UNITED STATES PATENT AND TRADEMARK OFFICE

10/789,637

Office Action Summary	Application No. 10/789,637	Applicant(s) SCHIECK ET AL.	
	Examiner KHANH B. DUONG	Art Unit 2822

DETAILED ACTION

FIG. 1

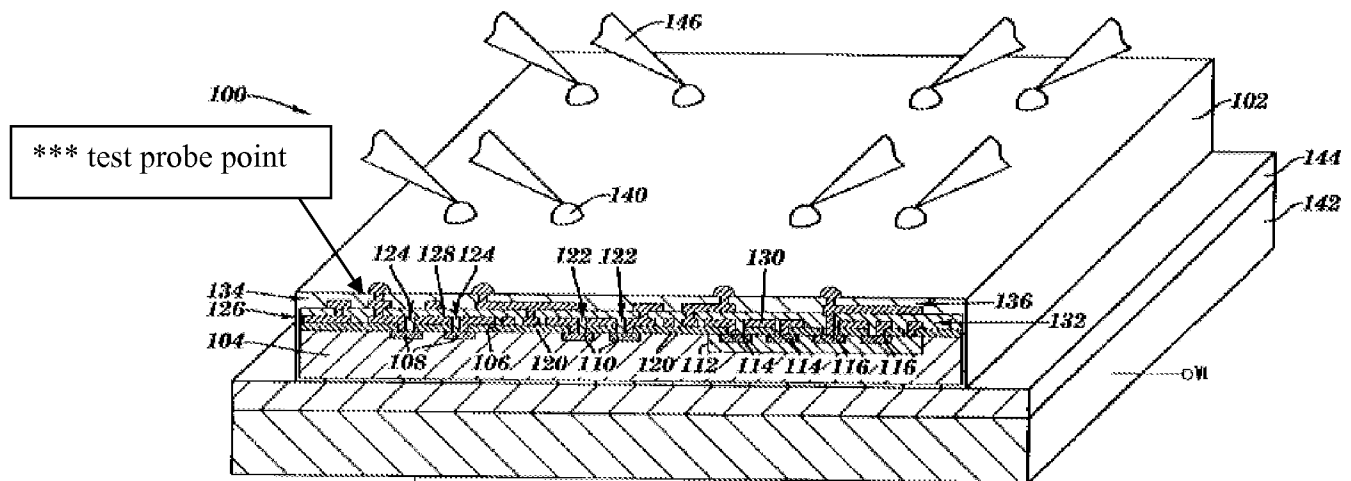
Re claim 1, Motika et al. (“Motika”) discloses in FIG. 1 a semiconductor die 102 comprising: a conductive test signal bump 140 for transmitting test signals off of said semiconductor die 102; a test signal redistribution layer trace **126** for communicating said test signals to said conductive test signal bump 140, wherein said test signal redistribution layer trace 126 is included in a redistribution layer (126/132/134) and said test signal redistribution trace 126 is disposed such that multiple test signals are accessible at varying degrees of electronic component granularity within said die 102 and along said test signal redistribution layer trace 126, said test signal redistribution layer trace 126 communicatively coupled to said conductive

test signal bump 140; and a test probe 136 point for accessing said test signals in said semiconductor die 102 and for electrical coupling to said redistribution layer.

Re claims 3-5, the claims recite the following product-by-process limitations: “accessible by drilling” (claim 3); “a focused ion beam (FIB) pad accessible by focused ion beam drilling and conductive material backfill” (claim 4); and “conductive material backfill” (claim 5).

However, these limitations have not been given patentable weight because product-by-process claims are not limited to the manipulations of the recited steps, only the structure implied by the steps. "[E]ven though product-by-process claims are limited by and defined by the process, determination of patentability is based on the product itself. The patentability of a product does not depend on its method of production. If the product in the product-by-process claim is the same as or obvious from a product of the prior art, the claim is unpatentable even though the prior product was made by a different process." *In re Thorpe*, 777 F.2d 695, 698, 227 USPQ 964, 966 (Fed. Cir. 1985). Thus, as shown in FIG. 1 of Motika above, the test probe point 136

comprises a bonding pad 136 which is coupled to said test signal redistribution layer (126/132/134), wherein the bonding pad 136 is communicatively coupled to said test signal redistribution layer trace 126 by a conductive material backfill.

Applicant persistently argues that Motika does not teach the semiconductor die comprising a test probe point for accessing the test signals in the semiconductor die. In response, the Examiner respectfully disagrees because Motika clearly shows in FIG. 1 a test probe 136 point for accessing said test signals in said semiconductor die 102 and for electrical coupling to said redistribution layer (126/132/134).

Applicant persistently argues that Motika does not teach “the test signal redistribution trace is disposed such that multiple test signals are accessible at varying degrees of electronic component granularity within the die and along the test signal redistribution trace”. In response, the Examiner respectfully disagrees because Motika clearly shows in FIG. 1 the test signal redistribution trace 126 is disposed such that multiple test signals are accessible at “varying degrees of electronic component granularity” within the die 102 and along the test signal redistribution trace 126. The “varying degrees of electronic component granularity”, in this case, can be interpreted as various number of electronic components on the substrate 104 within the die 102. Thus, the Examiner respectfully submits that no matter where a test point is moved

along the redistribution trace 126, it is limited to various number of electronic components within the die 102.
